STATE OF NORTH CAROLINA  
DEPARTMENT OF TRANSPORTATION

Subject: **Response to US Army Corps of Engineers Letter** for the proposed NC 133 Connector from NC 211-133 (Southport Supply Road) to NC 87-133 (River Road), Brunswick County, TIP R-3324.

References: Application for an Individual Section 401 Water Quality Certification dated July 19, 2012  
USACE Request for Additional Information Letter dated, September 18, 2012 (received September 24, 2012).  
NCDOT Response to US Army Corps of Engineers Letter dated, October 18, 2012.

# SITE IX

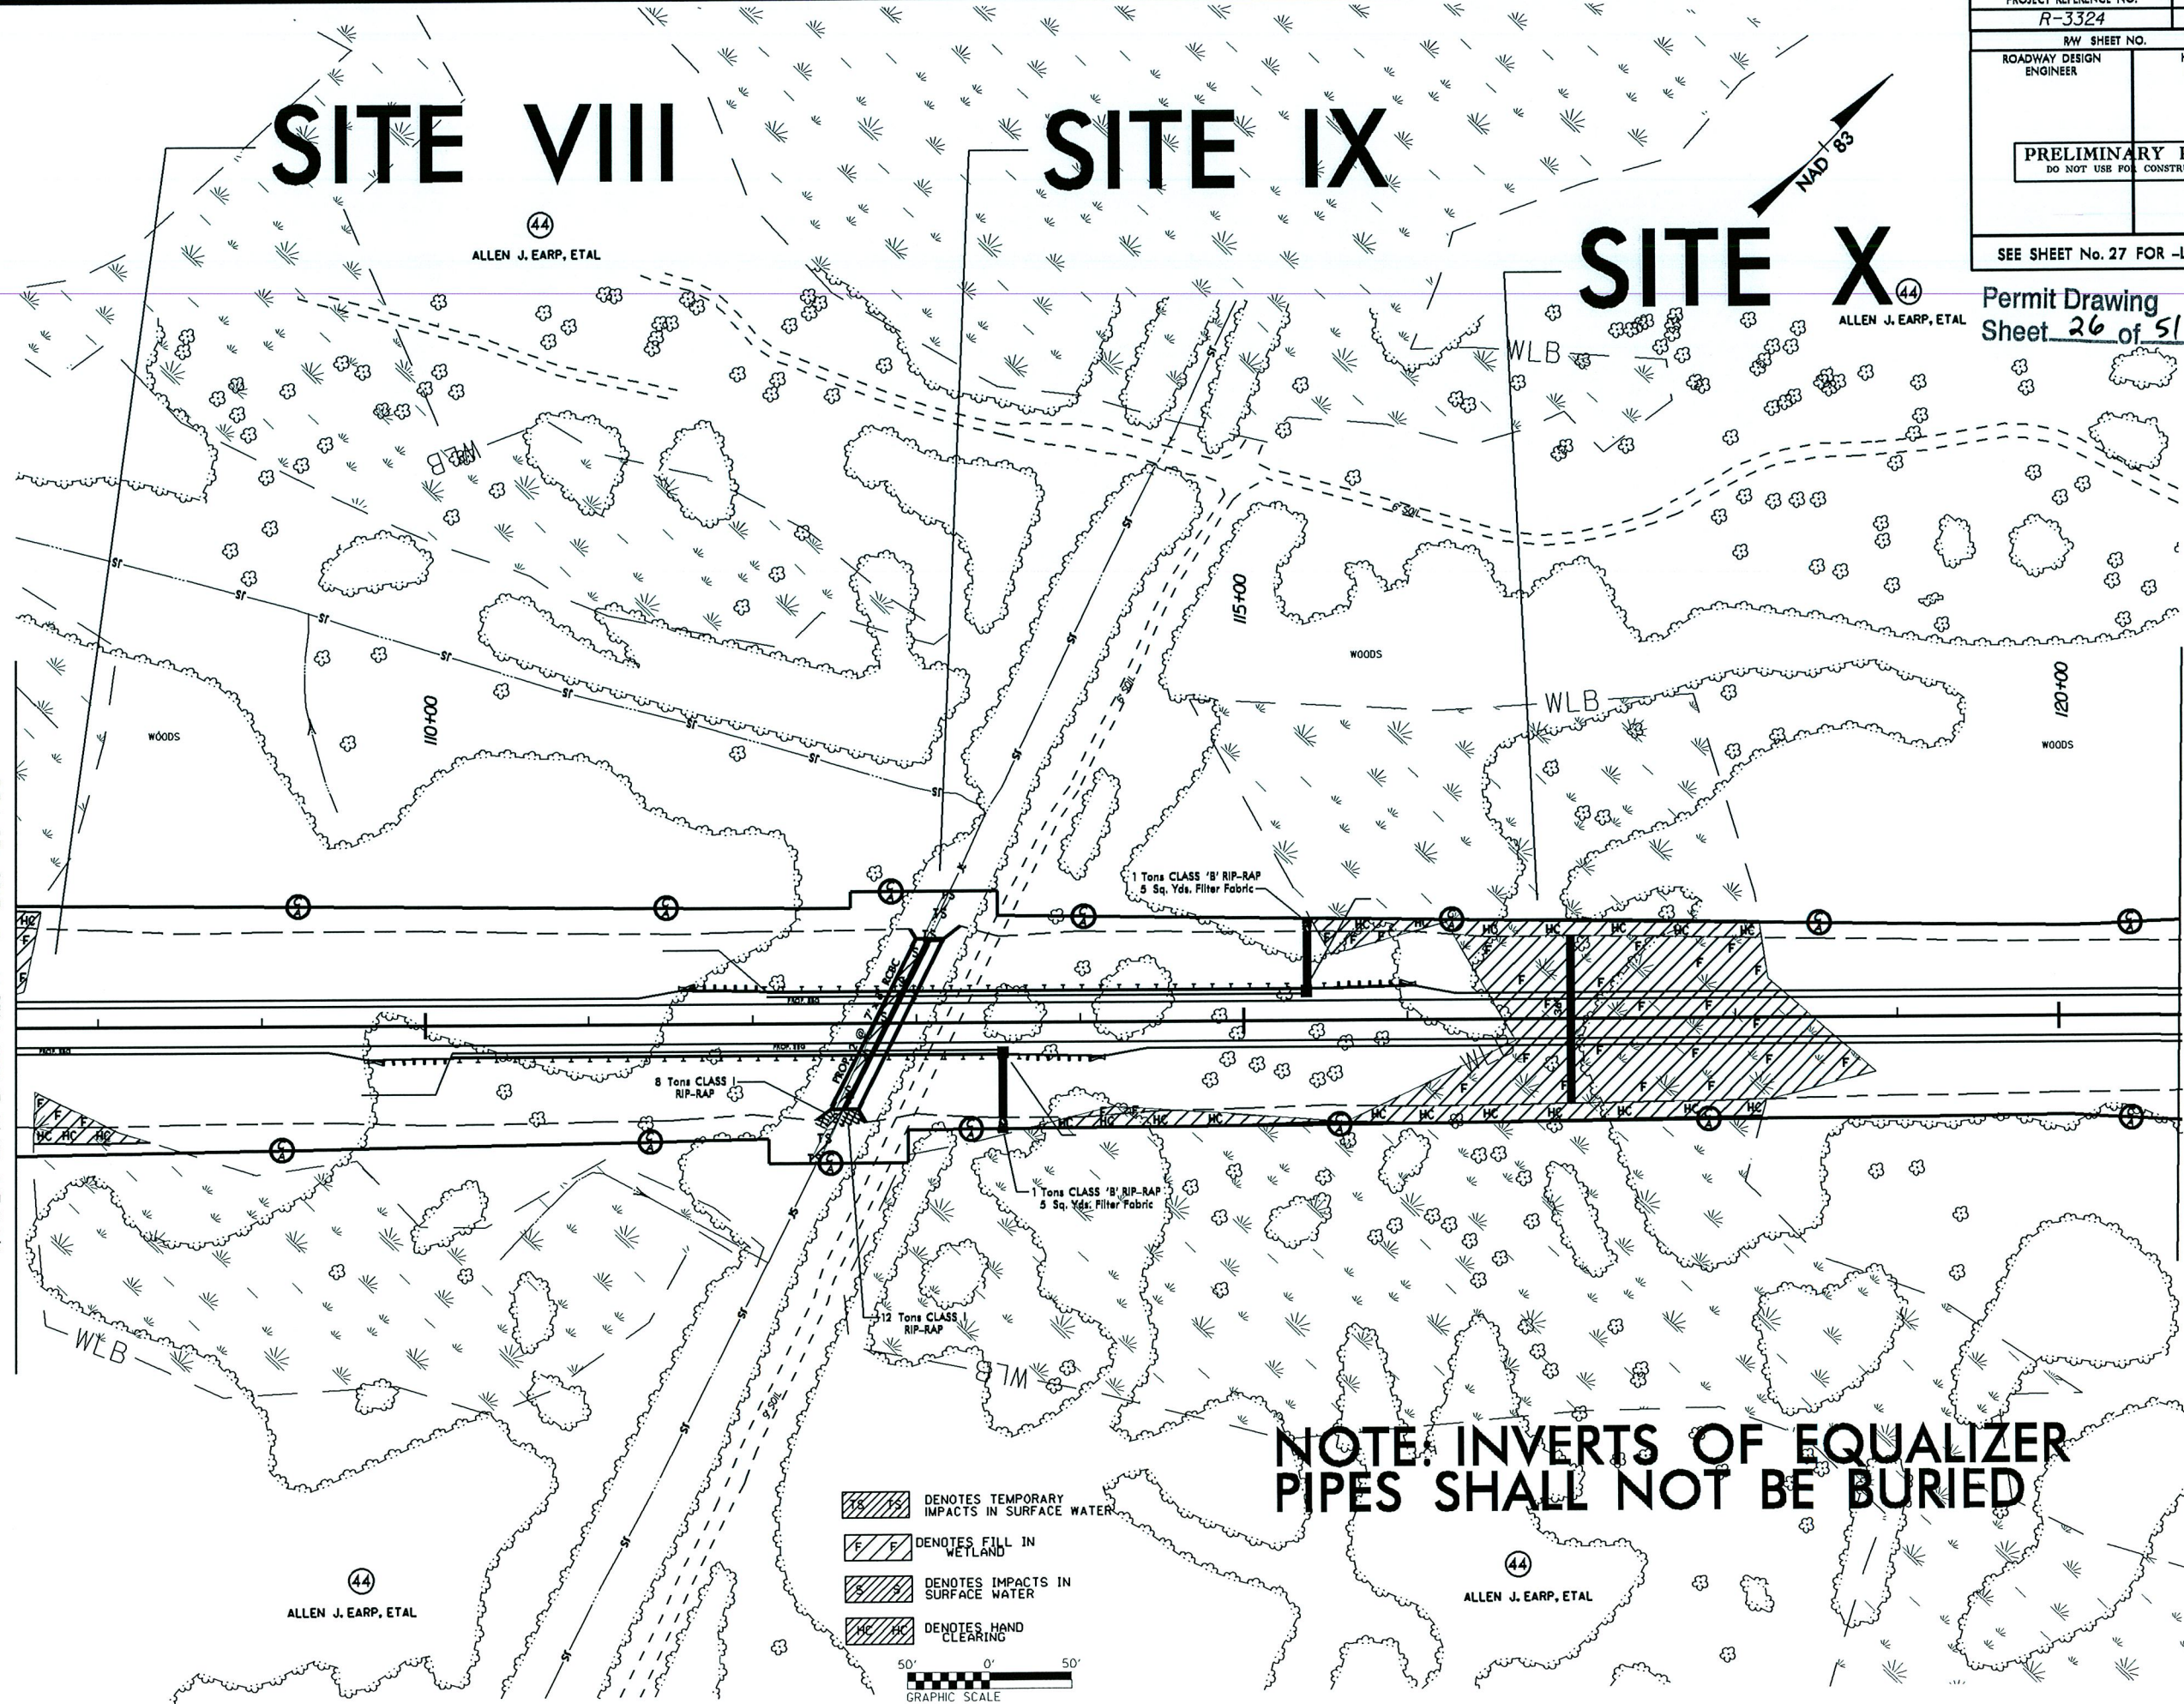
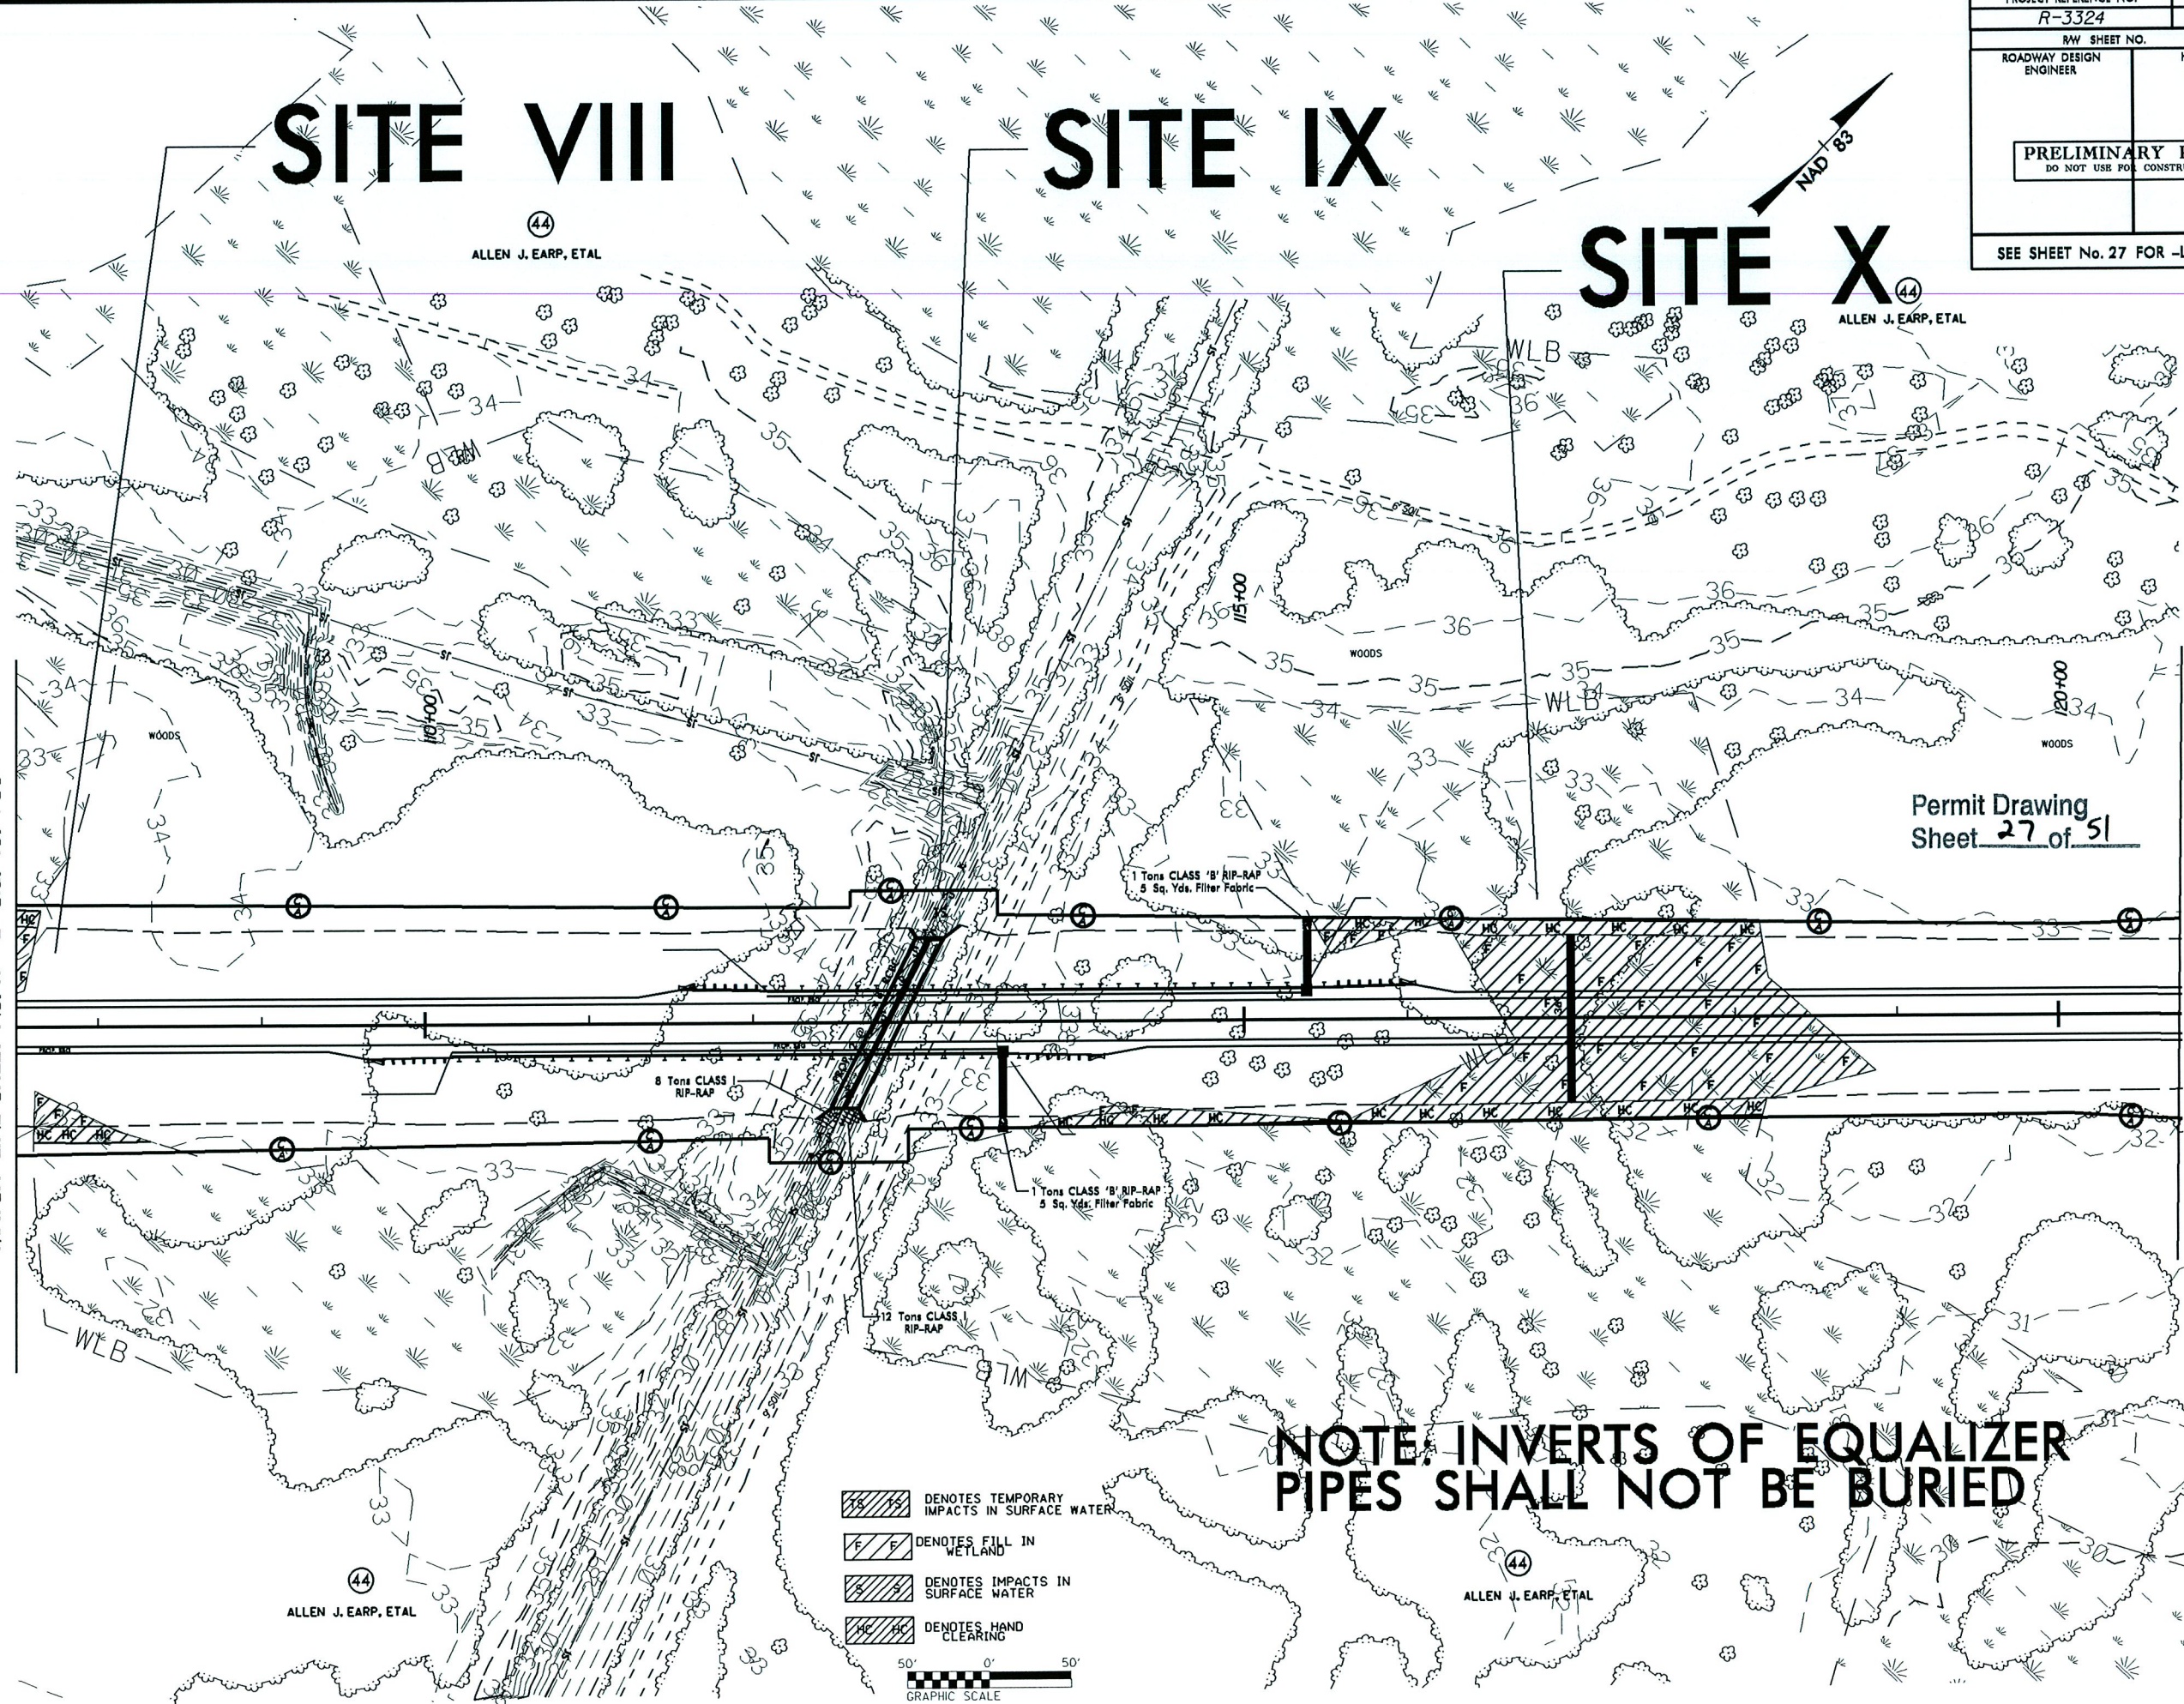
7. Sites 8 and 9: *NCDOT was asked to clarify if equalizer pipes will be buried or not on Sites 8*

The equalizer pipes at Sites 8 and 10 will not be buried. A note to this effect has been added to the permit drawings.
